Project	IEEE 802.16 Broadband Wireless Access Working Group < http://ieee802.org/16 >
Title	Proposed text and ASN.1 code to support multicast polling
Date Submitted	2007-05-08
Source(s)	Joey Chou Intel Corporation [mailto:joey.chou@intel.com]
Re:	
Abstract	This contribution proposes the text and ASN.1 code in wmanIf2Mib to support CID update TLV.
Purpose	Adoption
Notice	This document has been prepared to assist IEEE 802.16. It is offered as a basis for discussion and is not binding on the contributing individual(s) or organization(s). The material in this document is subject to change in form and content after further study. The contributor(s) reserve(s) the right to add, amend or withdraw material contained herein.
Release	The contributor grants a free, irrevocable license to the IEEE to incorporate material contained in this contribution, and any modifications thereof, in the creation of an IEEE Standards publication; to copyright in the IEEE's name any IEEE Standards publication even though it may include portions of this contribution; and at the IEEE's sole discretion to permit others to reproduce in whole or in part the resulting IEEE Standards publication. The contributor als

Figure 4— wmanIf2BsCps structure

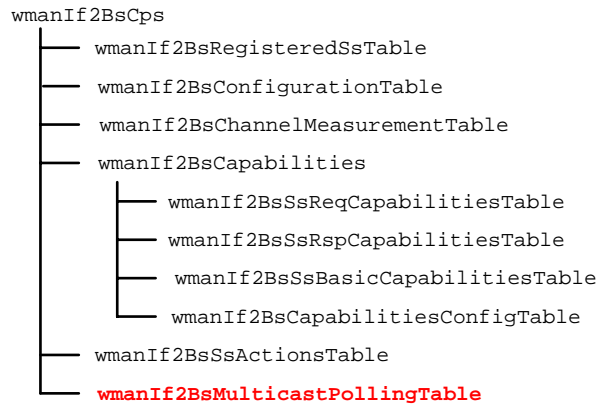
8 [Change Figure 4 as the following:]
